Access Compliance Report

Public Rights-of-Way

Intersection ID: 44267	Main Street: BRITTNI DAYLE DR	Cross Street: ISAAC HUNTER DR	Location: NE
ADA ID: AF71EA44BA35	Ramp Type: BlendTrans1	Initial Pass/Fail: Fail	Overall Compliance: No
			Severity Score: 21.25

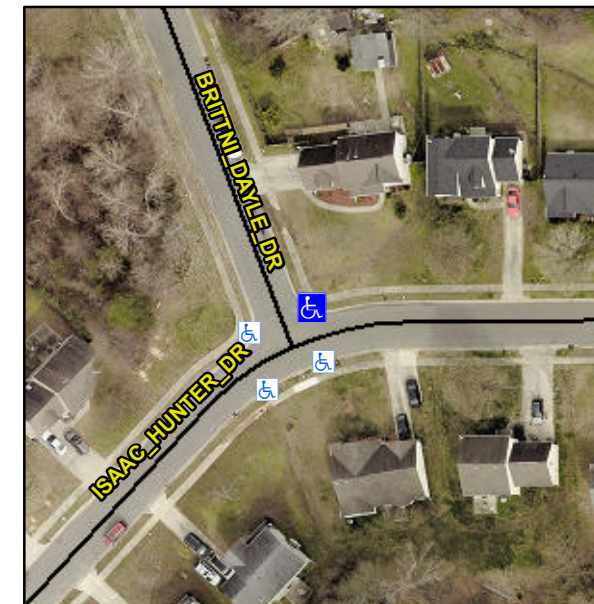
Not Found, R304.5.1, R304.5.3

Compliance	Description	Data	Compliance	Description	Data
N/A	Ramp Length (in)	42.5	Yes	BlendTrans Slope (%)	2.8
No	Ramp Width (in)	47.0	No	BlendTrans XSlope (%)	5.5
N/A	Flare Type LT	N/A	N/A	Flare Type RT	N/A
N/A	Flare Slope LT (%)	N/A	N/A	Flare Slope RT (%)	N/A
N/A	Flare Traversable LT?	N/A	N/A	Flare Traversable RT?	N/A
N/A	Landing Length (in)	N/A	N/A	DWS Provided?	N/A
N/A	Landing Width (in)	N/A	N/A	DWS Contrast?	N/A
N/A	Landing Slope (%)	N/A	N/A	DWS Length (in)	N/A
N/A	Landing X Slope (%)	N/A	N/A	DWS Full Width?	N/A
N/A	Landing Curb? (Y/N)	N/A	N/A	DWS Offset (in)	N/A
N/A	Shared Landing?	N/A			
N/A	Gutter Ponding?	N/A	N/A	Gutter Slope (%)	N/A
N/A	Gutter Lip Ht (in)	N/A	N/A	Gutter X Slope (%)	N/A
N/A	Painted X Walk1?	No	N/A	Painted X Walk2?	No
	X Walk 1 Direction	To W		X Walk 2 Direction	To S
	X Walk 1 Width (in)	N/A		X Walk 2 Width (in)	N/A
	X Walk 1 Slope (%)	0.4		X Walk 2 Slope (%)	4.7
	X Walk 1 X Slope (%)	4.6		X Walk 2 X Slope (%)	1.3

N/A	Ramp inside XWalk1?	N/A	N/A	Ramp inside XWalk2?	N/A
	Road Slope (%)	6.4		Clear Space?	N/A
	Road X Slope (%)	3.6	N/A	Clear Space to XWalk (in)	N/A
N/A	Any Obstructions?	N/A	N/A	Storm Grate/Utility Hazard?	N/A
	Obstruction Type			Storm Grate/Utility Type	
		N/A			N/A
			Yes	Surface Condition? (G/P)	Good
			No	Curb Slope (%)	7.0

Remove & Replace Curb Ramp With Two New Directional Ramps or Equivalent.
